Zoning Staff Report

Case Number: ZC-21-154

Zoning Map Amendment

PD 1298 PLANNED DEVELOPMENT SITE PLAN THE TRAILHEAD AT CHISHOLM TRAIL RANCH

Open Space Exhibit

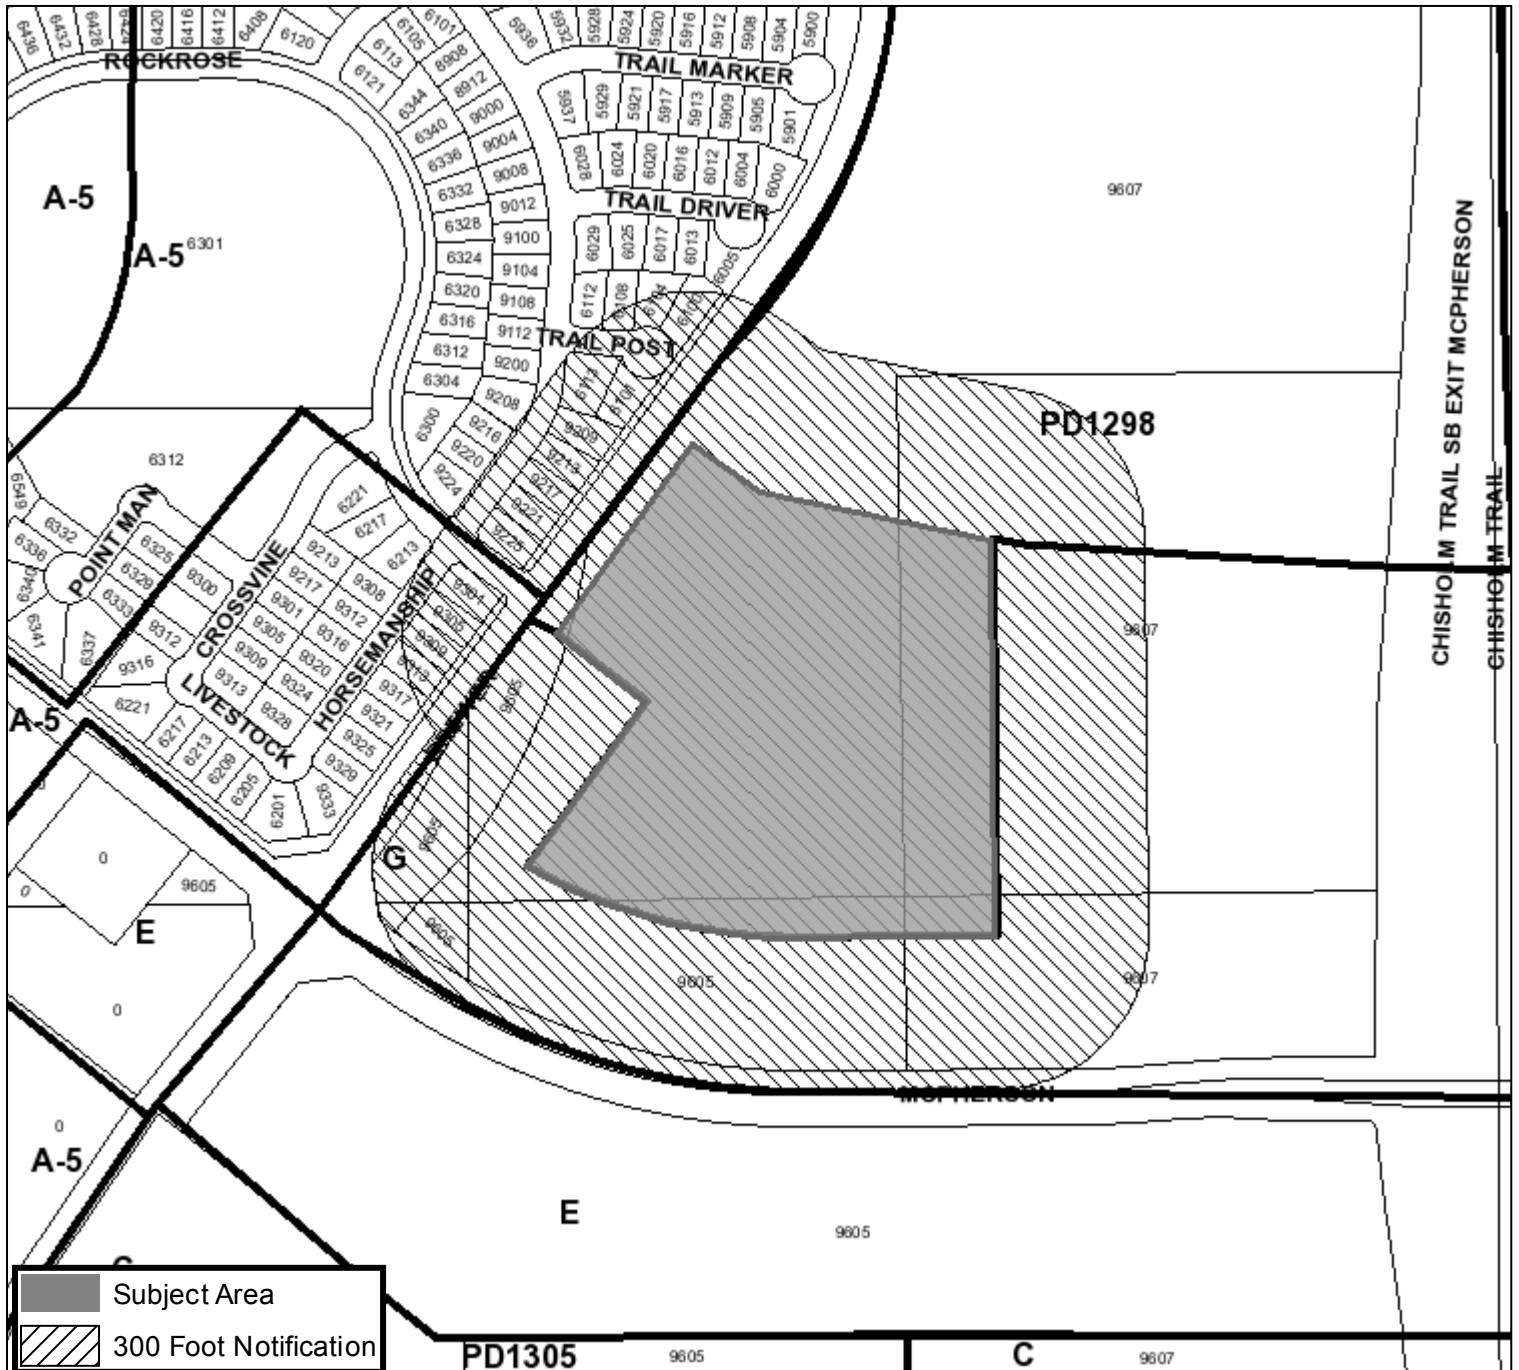
The below exhibit shows the areas the applicant is counting as open space, which total 32.8% where 45% is required—deficient by 12.2%.

Staff is not supportive of the reduction in open space. Open space waivers are often granted to detached multifamily PDs due to the more single-family form, but this is a standard “C” Medium Density Multifamily apartment development. A deficiency of this amount is a large difference. Staff is not supportive of a development standard to reduce the required open space percentage.

Additionally, the 2 acres detention pond area at the front of the site is not supposed to be counted as open space, as it is largely separated from the apartment buildings by a proposed 6-foot metal fence. The applicant has stated part of this is for “security to the pool adjacent”; staff understands why a 6-foot security fence would be desired around the pool area to separate it from the public access in the front yard; staff is supportive of this portion being 6-foot in height. The applicant has indicated the rest is a “metal fence provided here for fall protection”. Staff does not support the 6-foot metal fence separating the apartment buildings from the detention pond open space area. The presence of a fence means the detention pond area should not be counted as open space. However, staff would support including it in the open space calculation if the 6-foot metal fence were reduced to a 4-foot open style fence, such as the 4-foot split rail fence proposed along the front yard perimeter. Staff believes a 4-foot split rail fence would be less divisive, providing more connectivity between the open space and the residents. A 4-foot fence would also still act as a fall protection fence, thus achieving its purpose as stated by the applicant.

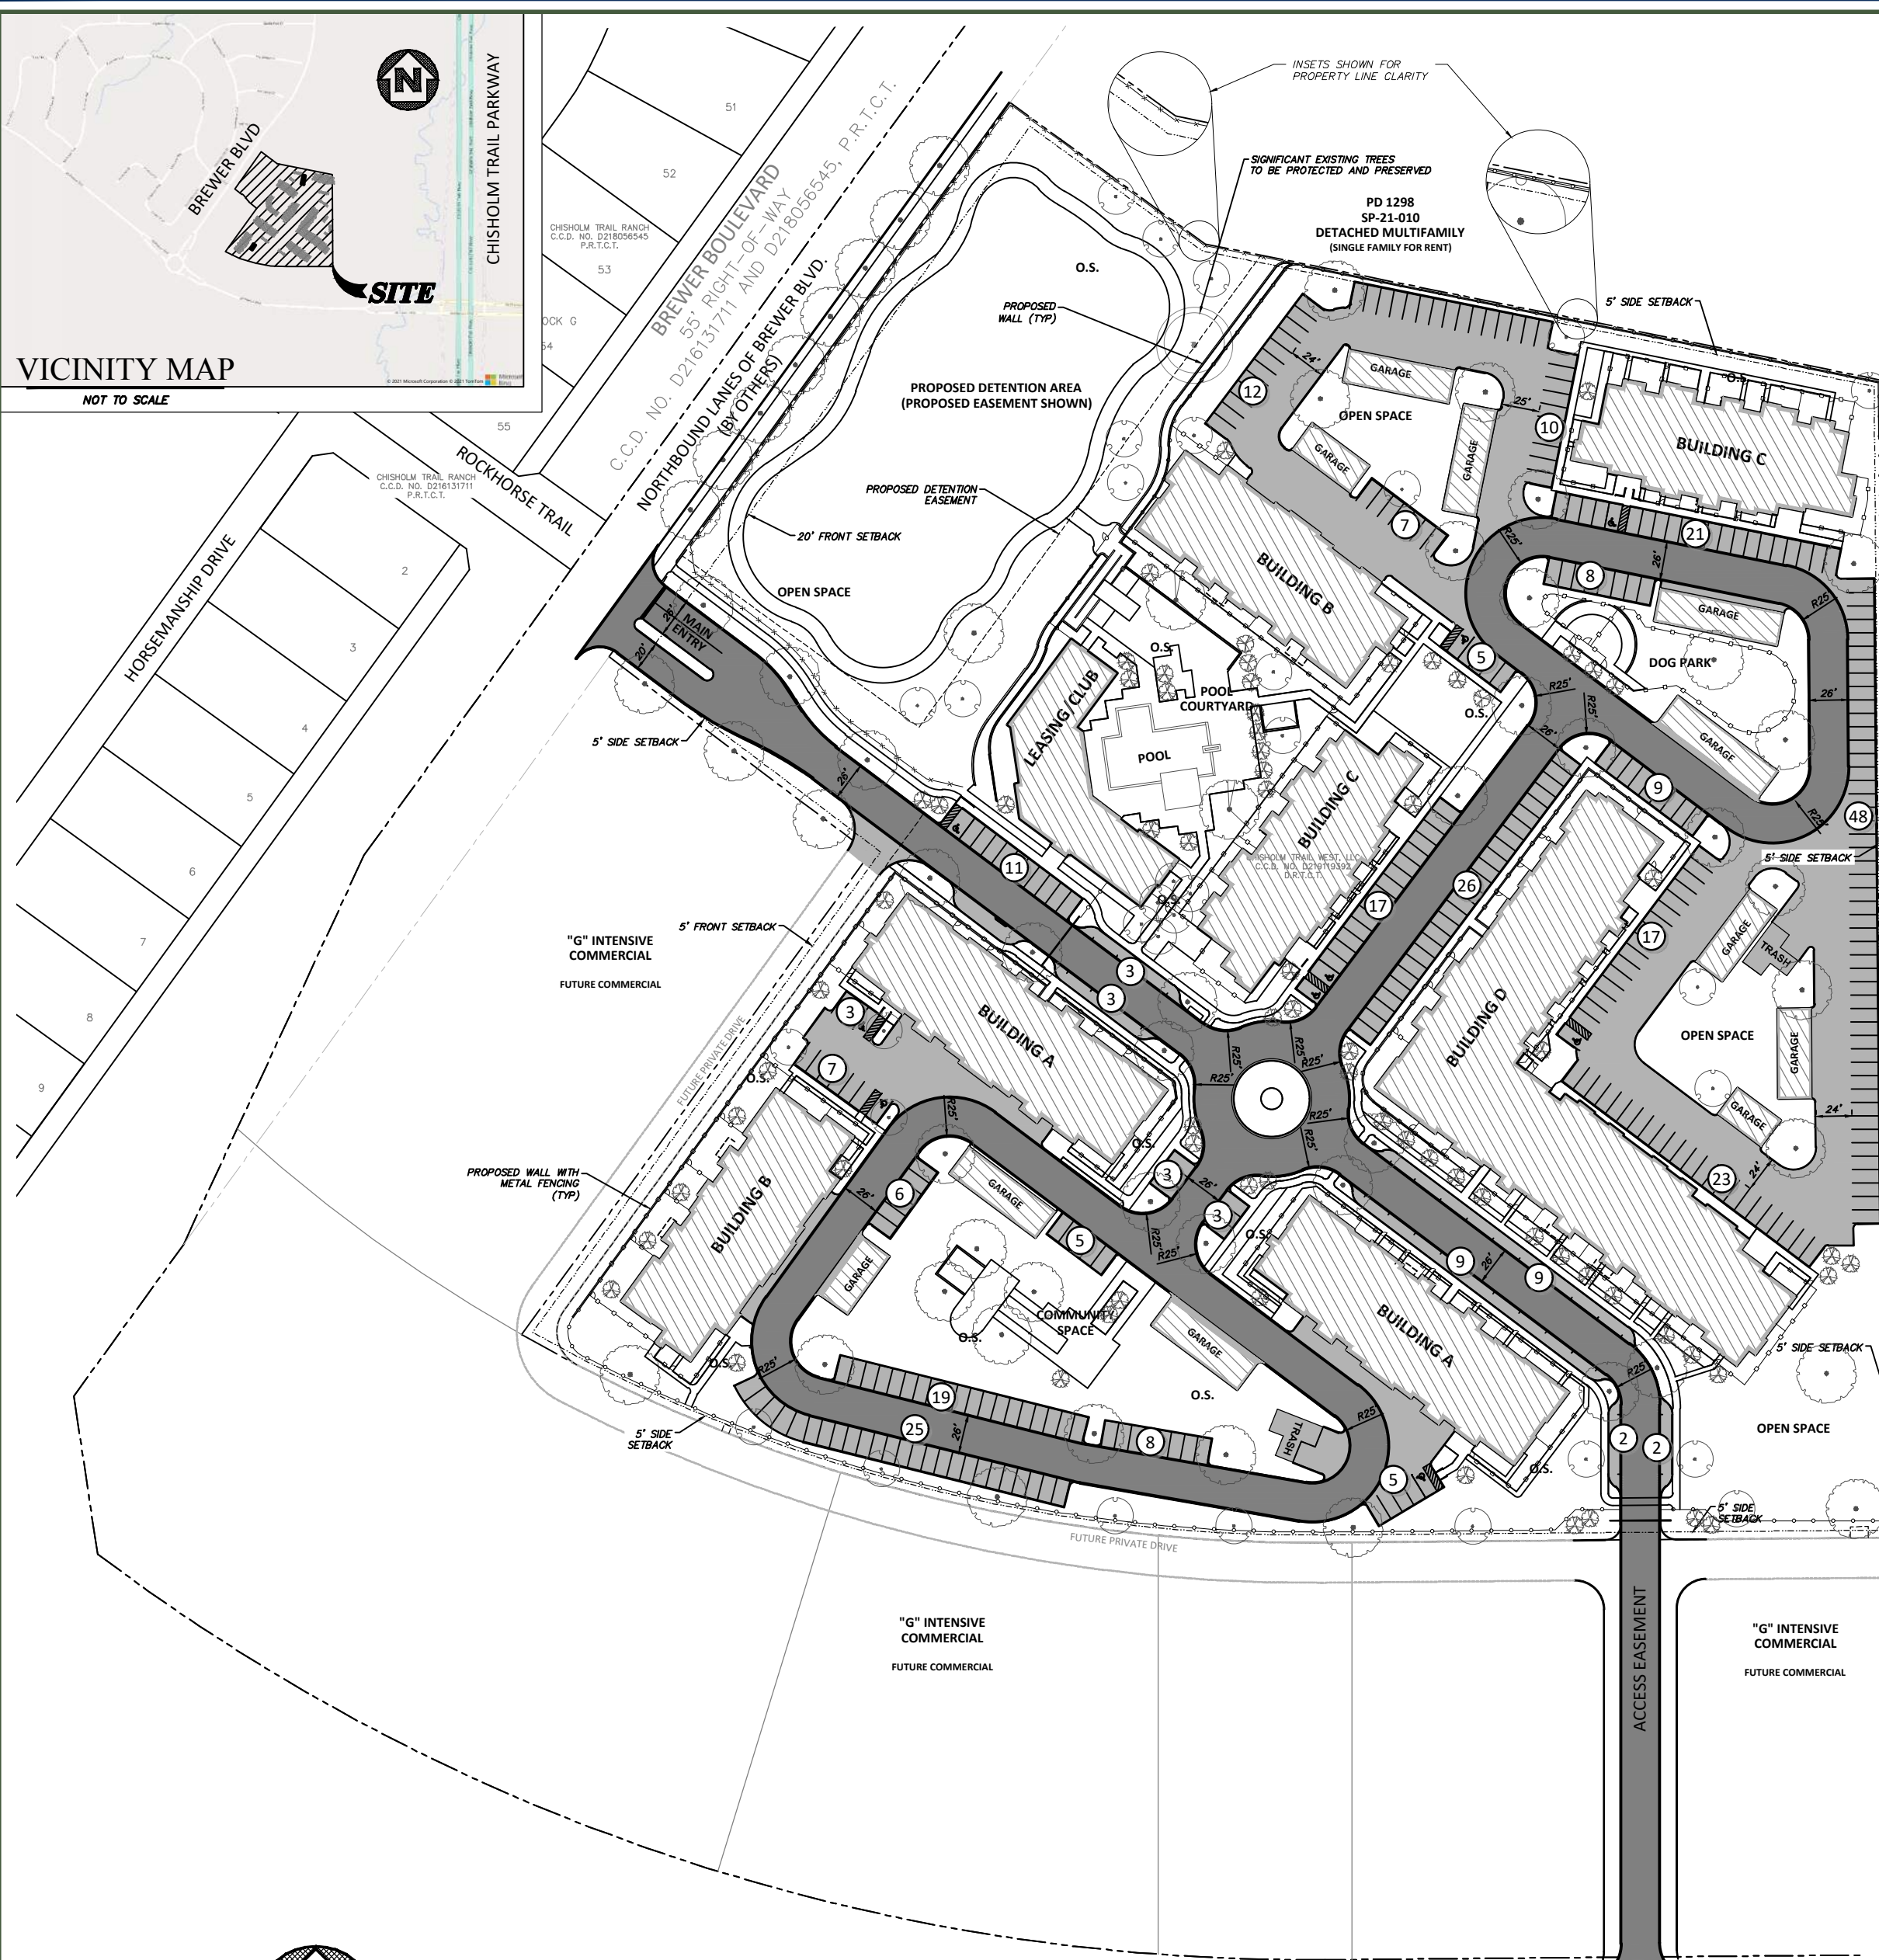
- Transportation (Armond Bryant, 817-392-8702, Armond.Bryant@fortworthtexas.gov)
 1. Gate at southern entrance requires 3 car stacking and turn around.
 2. Label public and private access easements accordingly.
